BRENT ACRES SUBDIVISION, RESUBDIVISION OF LOTS 3 AND 4

APPLICATION NUMBER 2 DATE May 5, 2016
APPLICANT Brent Acres Subdivision, Resubdivision of Lots 3 and 4
REQUEST Subdivision

DETAIL SITE PLAN

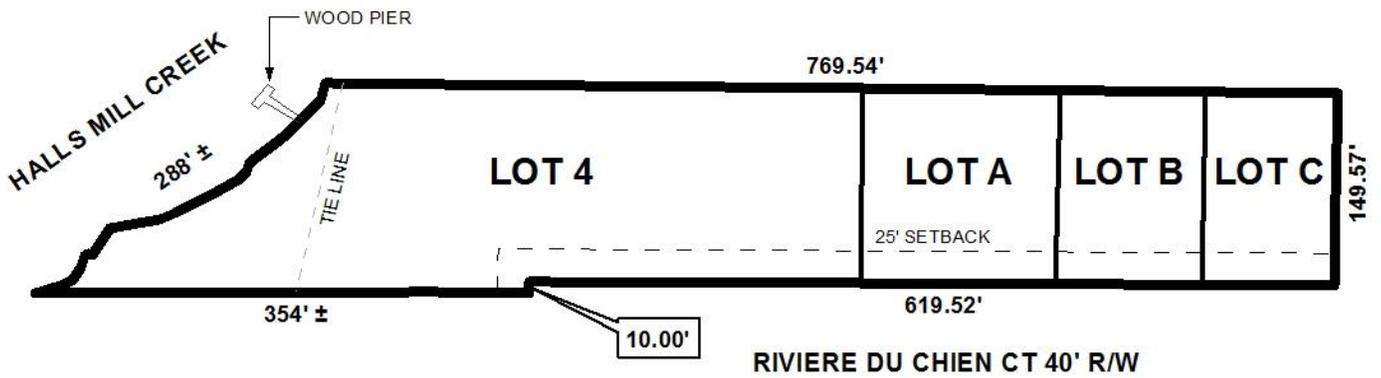
The site fronts onto Riviere du Chien Court, a minor street with a substandard 40' right-of-way. Dedication was recorded via the original Subdivision to provide 25' from the centerline of Riviere du Chien Court; therefore, no further dedication would be required. The plat indicates

the 25' minimum building setback line along Riviere du Chien Court and this should be retained on the Final Plat.

As a means of access management, the Final Plat should retain the note stating that the driveway number, size, location and design are to be approved by Traffic Engineering and conform to AASHTO standards.

Each lot meets the minimum area and width requirements of the Subdivision Regulations. As on the preliminary plat, the Final Plat should also label each lot with its size in both square feet and acres, or a table should be furnished on the Final Plat providing the same information.

- 1) retention of the 25' minimum building setback line along Riviere du Chien Court;
- 2) retention of the note on the Final Plat stating that the driveway number, size, location and design are to be approved by Traffic Engineering and conform to AASHTO standards;

- 3) retention of the labeling of each lot with its size in square feet and acres, or the furnishing of a table on the Final Plat providing the same information;
